Access Design Assessment Report
Development Application

WEM – New Parramatta Showroom
574 - 584 Church Street,
Parramatta NSW 2150

Project: West End Mazda Dealership, Parramatta
 Document Type: Access Design Assessment Report
 Our Reference: P220_040-2 (ACCESS) JLS

Figure 1 – Pedestrian Entry – Barney Street

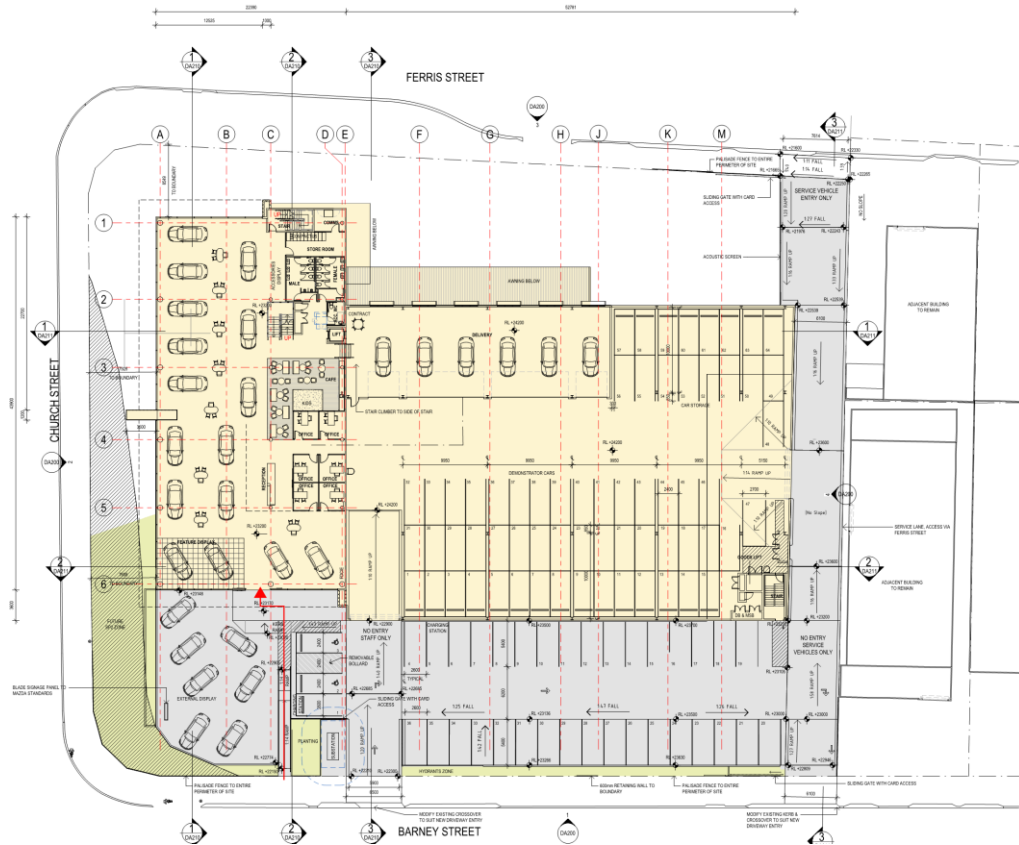
Entry Door – Threshold (Barney Street)	RLs shown on the drawings indicate that there is a 30mm floor difference between internal and external finished floor levels.	If a flush threshold at the entry sliding door is not provided, ensure a threshold ramp compliant with AS1428.1-2009 is provided.
Entry Door – Threshold (Ferris Street)	RLs shown on the drawings indicate a 100mm threshold at the Ferris Street entry door.	<p>Detail of this area and transition between the car park FFL and internal FLL is to be confirmed.</p> <p>If a flush threshold at the entry sliding door is not provided, ensure a threshold ramp or step ramp compliant with AS1428.1-2009 is provided.</p>
Ramp passing space (Ferris Street)	A passing space is not provided along the series of ramps at the pedestrian entry.	On an accessway greater than 20m and where a direct line of site has not been provided, a passing bay of 1800mm x 2000mm is required, compliant with the BCA and AS1428.1-2009.

Figure 2 – Pedestrian Entry – Ferris Street

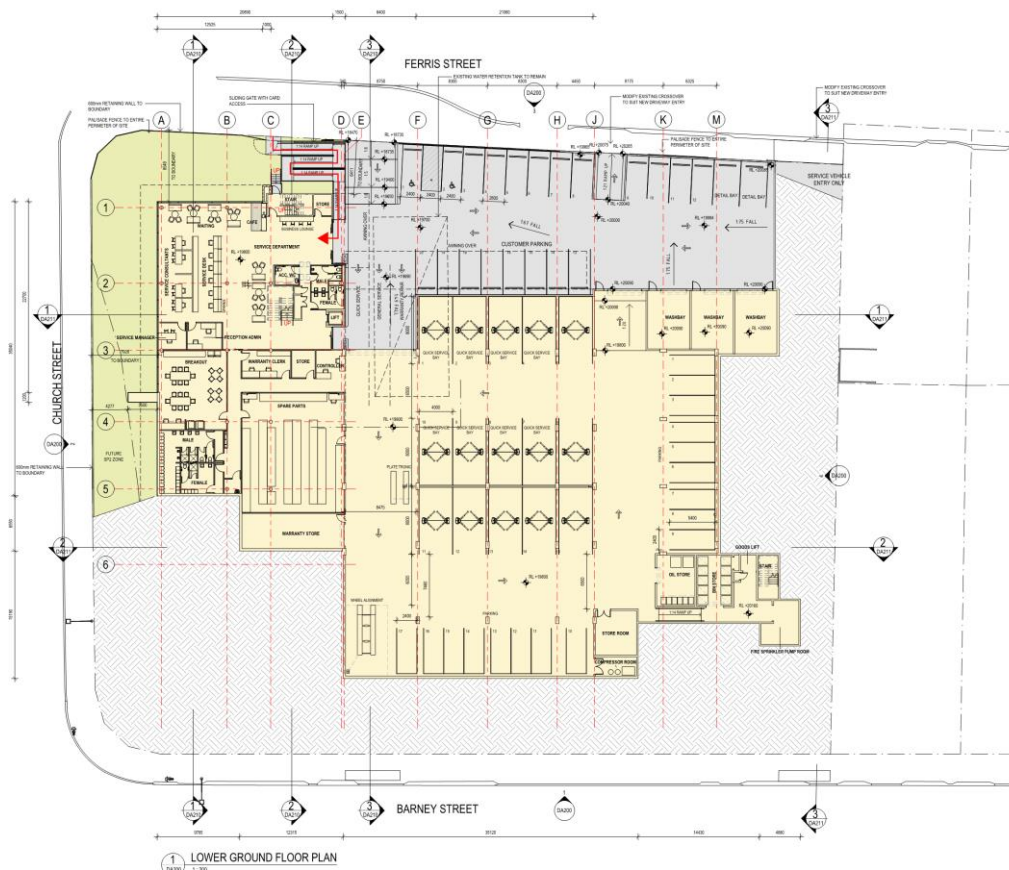
DESCRIPTION	COMMENT	SOLUTION
Entry Gate (Ferris Street)	<p>The entry gate at the Ferris Street has been provided with the following non-compliances:</p> <ul style="list-style-type: none"> - Not set-back from the site boundary. - Reduced latch side clearance is provided to both sides of the gate. 	<p>Entry gate to be provided with the following to ensure compliance with AS1428.1-2009 is achieved:</p> <ul style="list-style-type: none"> - Entry gate is to be set-back from the site boundary a minimum 1450mm to ensure compliance circulation spaces are achieved in front of the entry gate. - Ensure where the gate swings towards the user, a minimum 900mm latch side clearance is provided (latch side approach). <p>Where the gate swings away from the user, a minimum 510mm latch side clearance is provided.</p> <p>Note: Alternatively, Design Confidence can provide a performance-based solution if compliance requirements can't be achieved</p>

Ramps – turning space 180° (Ferris Street)	Reduced turning space for an 180° turn is provided at the mid-landings of the Ferris Street entry ramp, being ~1330mm wide between handrails.	At a mid-landing to a ramp which turns 180 degrees, a minimum 1540mm width is required between handrails, compliant with AS1428.1-2009.
Ramp Landings/set back	The entry ramp at the Barney Street entrance is setback ~900mm from the boundary.	Ramp is to be setback a minimum 1200mm from the site boundary to allow for a compliance bottom

LOWER GROUND FLOOR PLAN

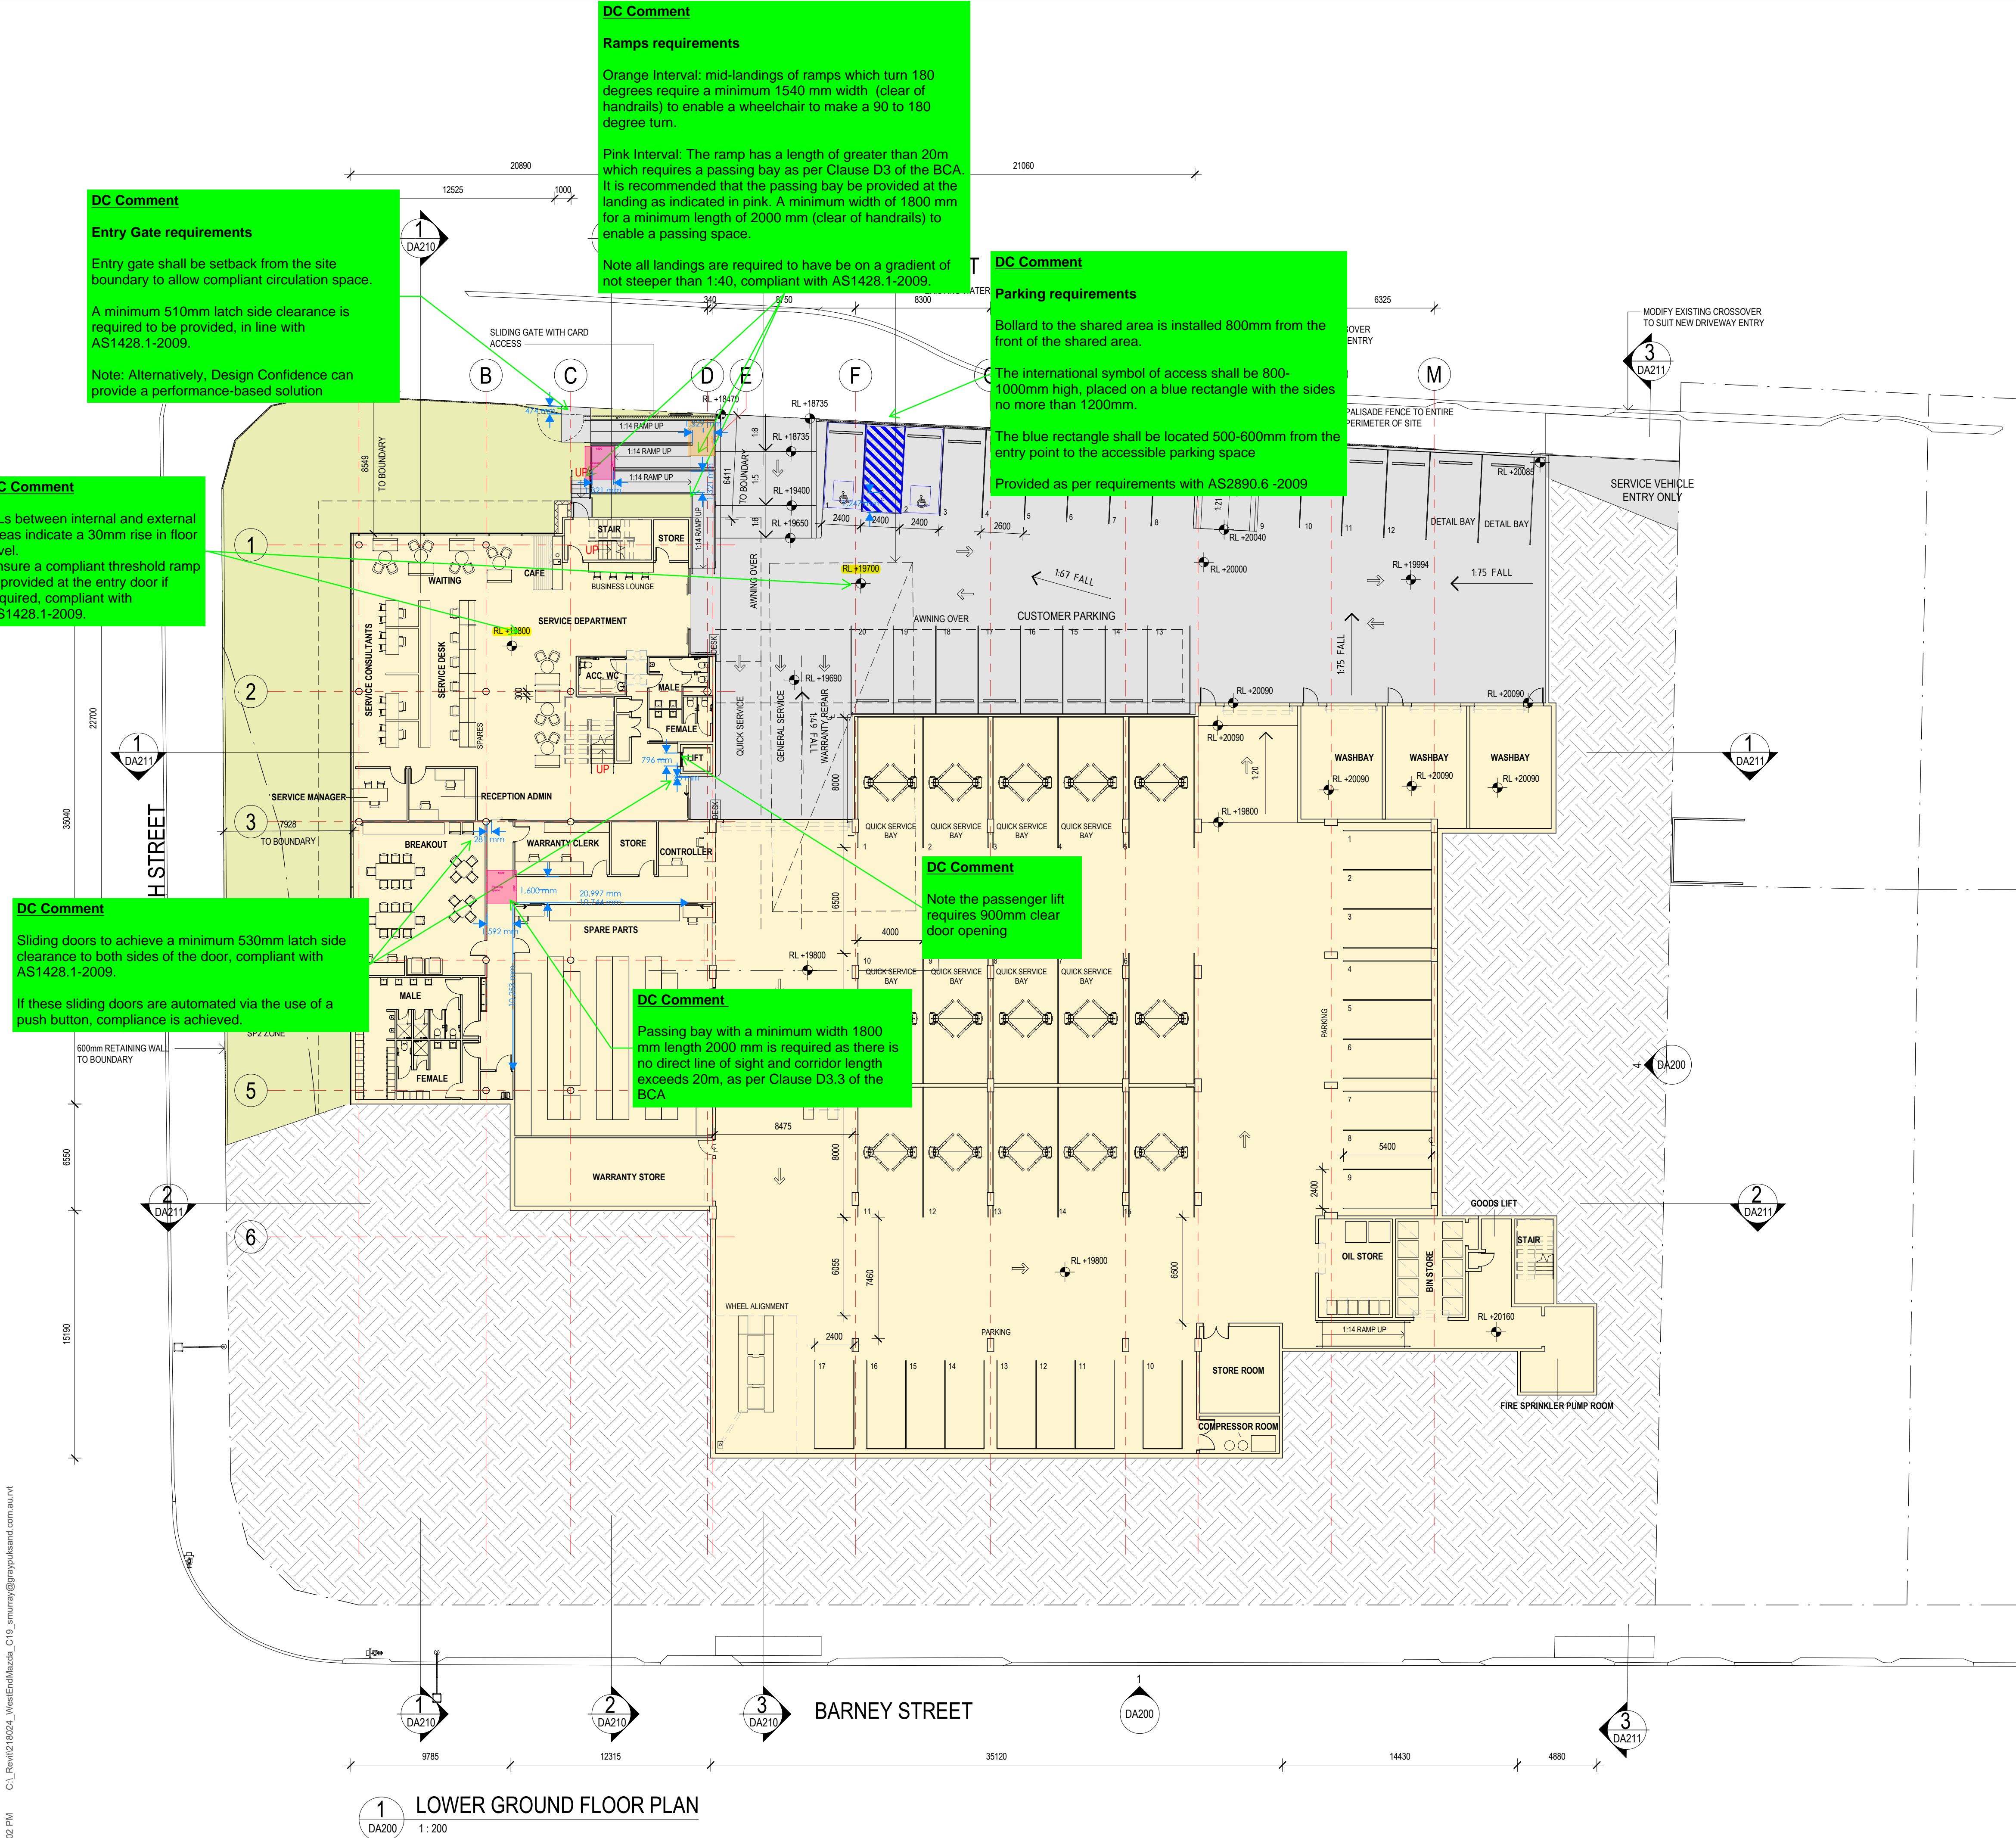
DC Comment

Note: Alternatively, Design Confidence can provide a performance-based solution

DC Comment

DC Comment

DC Comment

DC Comment

DC Comment

GROUND FLOOR PLAN

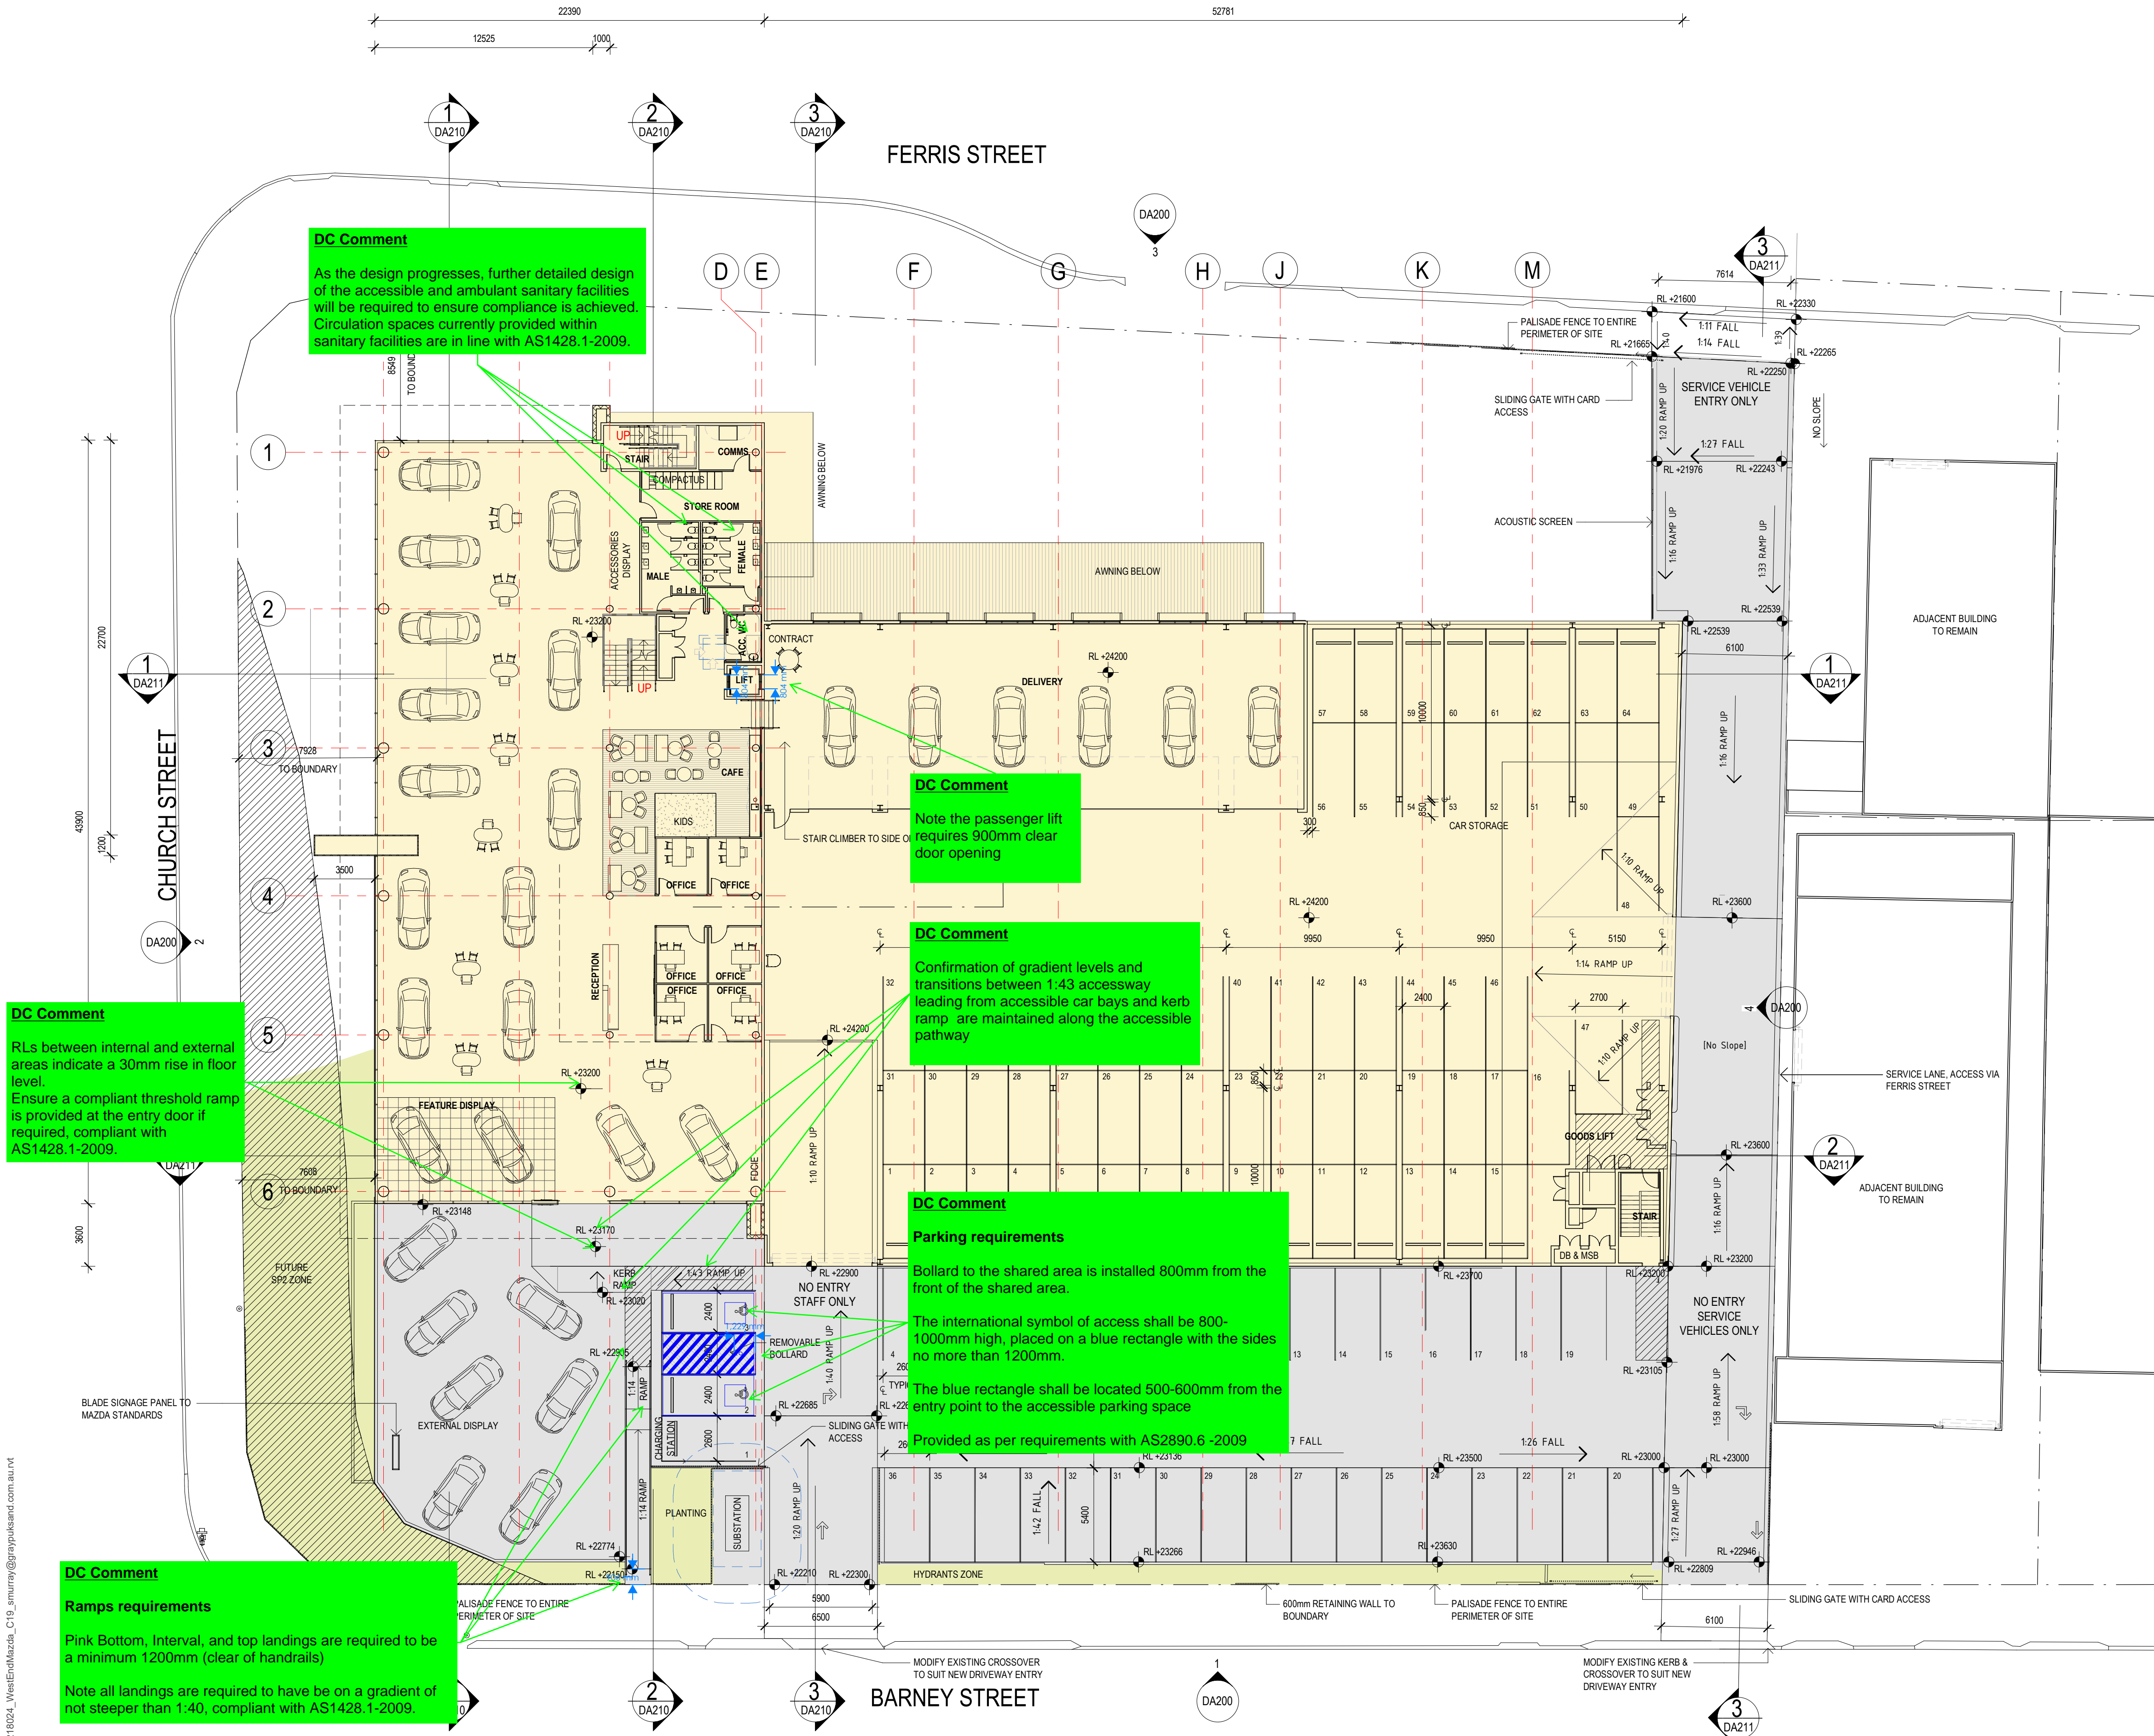
DC Comment
RLs between internal and external areas indicate a 30mm rise in floor level.
Ensure a compliant threshold ramp is provided at the entry door if required, compliant with AS1428.1-2009.

DC Comment
As the design progresses, further detailed design of the accessible and ambulant sanitary facilities will be required to ensure compliance is achieved. Circulation spaces currently provided within sanitary facilities are in line with AS1428.1-2009.

DC Comment
Note the passenger lift requires 900mm clear door opening

DC Comment
Confirmation of gradient levels and transitions between 1:43 accessway leading from accessible car bays and kerb ramp are maintained along the accessible pathway

DC Comment
Parking requirements
Bollard to the shared area is installed 800mm from the front of the shared area.
The international symbol of access shall be 800-1000mm high, placed on a blue rectangle with the sides no more than 1200mm.
The blue rectangle shall be located 500-600mm from the entry point to the accessible parking space
Provided as per requirements with AS2890.6 -2009

DC Comment
Ramps requirements
Pink Bottom, Interval, and top landings are required to be a minimum 1200mm (clear of handrails)
Note all landings are required to have be on a gradient of not steeper than 1:40, compliant with AS1428.1-2009.
